Form 504 Ed. June, 1928	
DEPARTMENT OF COMMERCE	
U. S. COAST AND GEODETIC SURVEY	
R. S. Patton, Director	
State: New York	
U. S. COAST & GEODETIC SURVEY LIBRARY AND ARCHIVES MAR 8 1934	
DESCRIPTIVE REPORT	
Topographic Hydrographic	Sheet No. T5080
LOCALITY	
South Shore of Long Island	
Outer Coast between Header Creek	
and Tiana Beach	
1933	
CHIEF OF PARTY	
Roswell C. Bolstad, Jr. H. & G. E.

Locality Outer Coast between Header Creek and Tiana Beach

FIELD REPORT  
for  
AIR PHOTO TOPOGRAPHIC SHEET FIELD (NO. 30)

COMPILER'S REPORT  
for  
AIR PHOTO TOPOGRAPHIC SHEET FIELD NO. 30

GENERAL DESCRIPTION OF TOPOGRAPHY.

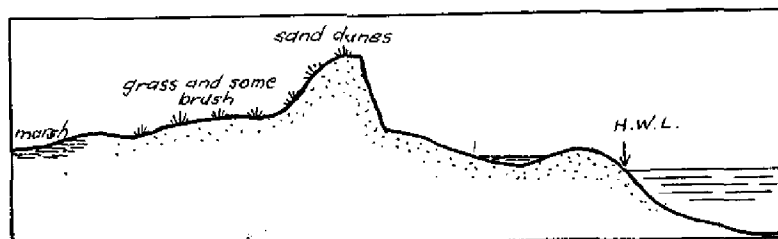
\* The H.W. line as shown on this sheet is considered correct as of the date of the photographs. The low ridge of island at H.W. line as shown in the sketch on page 1 may have washed out prior to the date of the planotable survey several months after the photographs were taken. It seems probable from the discussion on page 1 that this ridge is frequently washed out and then built up again.
